Product Change Notification / ALAN-14CQYK486

CCB 3582.001 Final Notice: Qualification of inductor LQM21PNR47MCH# for selected Micrel MIC38150HYHL-TR catalog part number (CPN) available in 28L VQFN (4x6x0.9mm) package.

CCB 3582.001
Pre and Post Change Summary
PCN# ALAN-14CQYK486

Pre Change

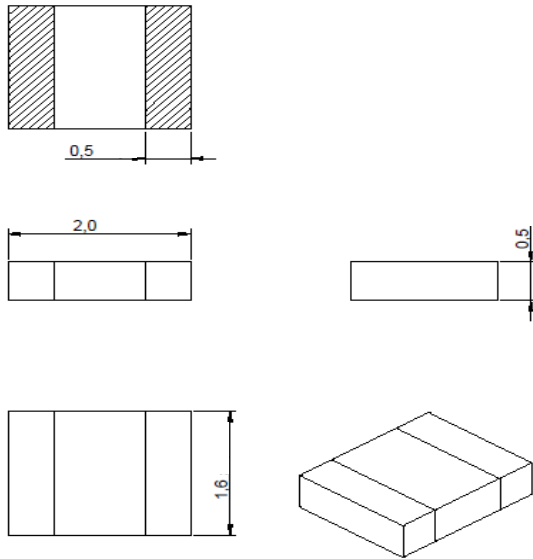
Inductor Part Number	74479977147
Package	2 x 1.6 x 0.5 mm

Post Change

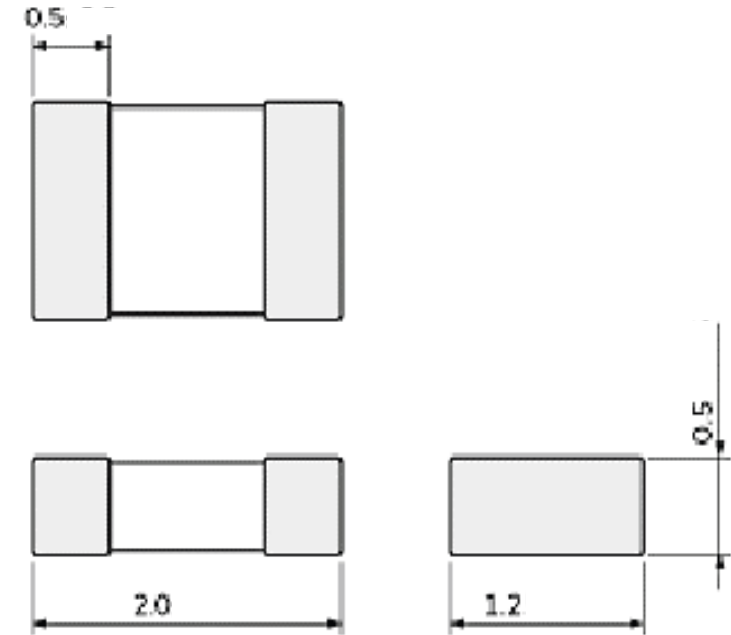
Inductor Part Number	LQM21PNR47MCHL
Package	1.25 x 2.0 x 0.5 mm
